P7 [PD-PC] Section 96 Applications DA02/1422.42 & DA02/1423.13 for Amendment to Development Consents DA02/1422 & DA02/1423 for a 473 Lot Subdivision & Tourist Resort (Outrigger) at Lot 194, 301, 312 DP755701; Lot 490 DP47021; Lot 500 DP727420, Tweed Coast R

FILE NO: DA02/1422 Pt 45 & DA02/1423 Pt 10

BASEMENT 1 - RL24,000

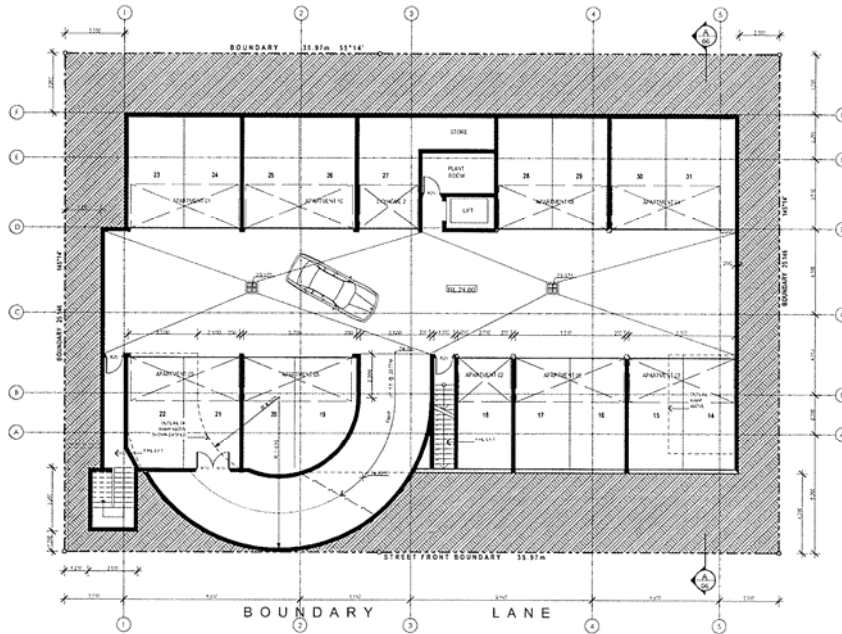
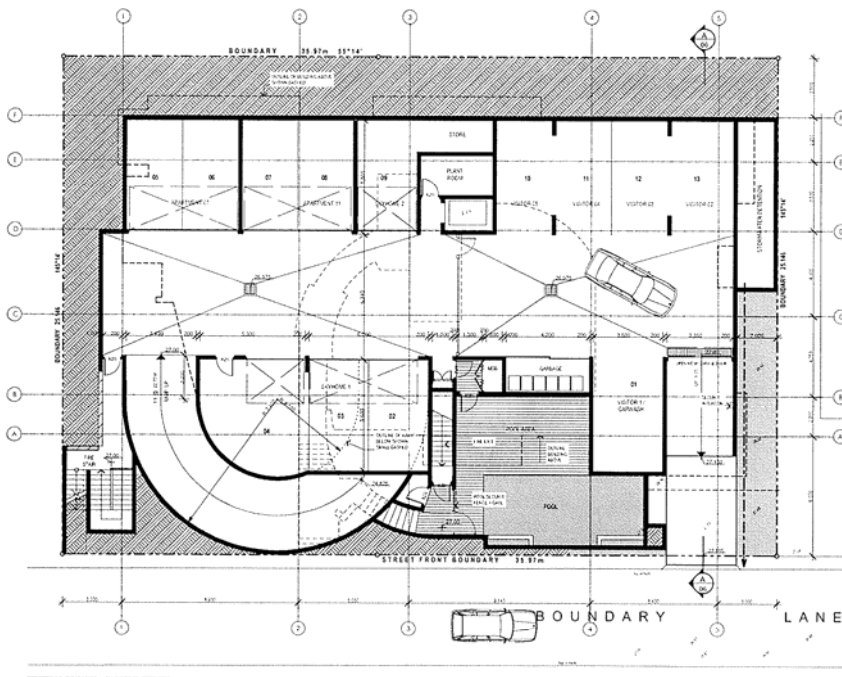
The proposed amendment seeks to convert the single unit within level 4 to two (2) units. On the approved plans the apartment on level 4 occupied 475m² of internal and balcony space. The proposal is to divide this same space into two apartments of 255 m² and 220m².

However, to accommodate the additional unit the plans indicate that on level 4 the pool has been deleted and replaced with internal floor area and balcony space. The setbacks from the main external wall of the building will therefore be reduced from 6m down to 4m for a length of 20m. This will affect the south-eastern elevation.

In addition the amended plans show alterations to level five with new balcony space to cover the additional floor area on level four.

On review of the amended plans it is agreed that the proposed amendments continue to achieve compliance with the design quality principles in SEPP 65, the requirements within DCP 18 – Tweed Heads, and the Tweed Heads Master Plan. Specifically in regard urban design principles, the extent of balcony area per unit, and the building height plane.

The reduced setback at level 4 and the additional balcony area at level five are considered reasonable as the privacy implications are minimal. In regards to the increased loss of privacy from one additional unit this has to be balanced against the approved floor plan. The approved plan showed a pool and entertainment area, while the proposed amendment shows bedrooms and small narrow balconies.

SEAN GARTNER ARCHITECTS		NEW APARTMENTS 2 & BOUNDARY LANE, TWEED HEADS		Date: 15/08/2006	
		ELEVATION NE - SECTION A-A		Drawing No: A-07		Rev: B

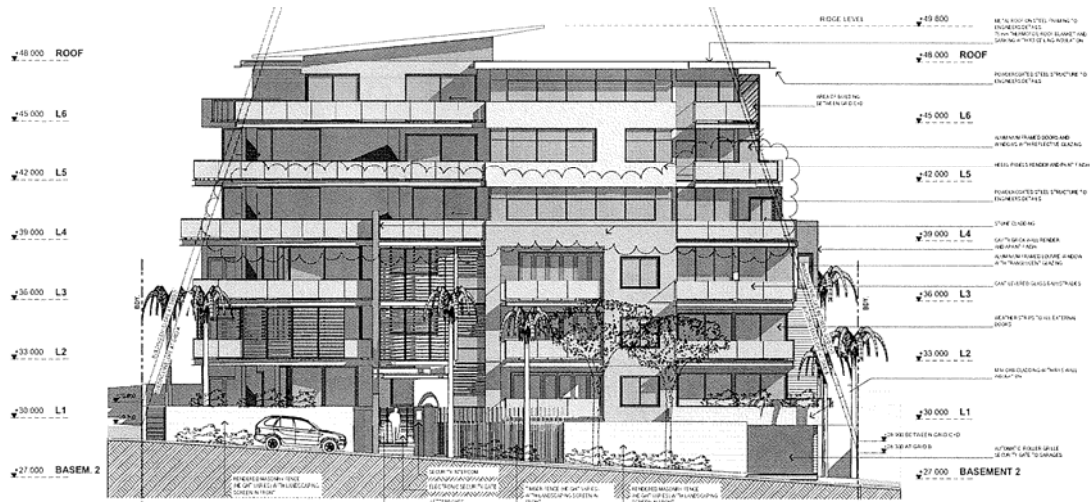
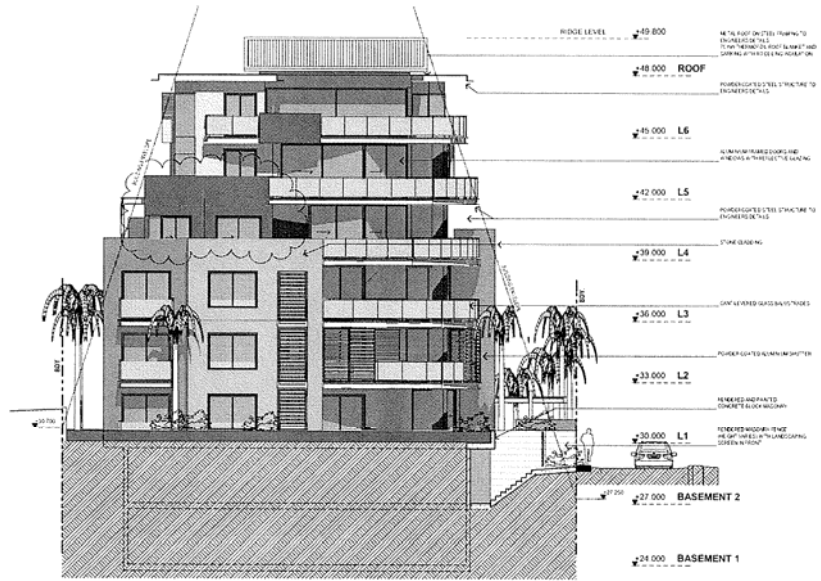
The proposed amendments to the building to accommodate one additional unit will not change the overall height of the building or the footprint of the building. It will however decrease the setbacks to the south-eastern boundary at level 4 and increase the amount of balcony space at level 5. These changes will change the south-eastern elevation and thus potentially alter the privacy of those adjoining residences. The changes will also increase traffic using Boundary Lane and increase the required onsite parking spaces.
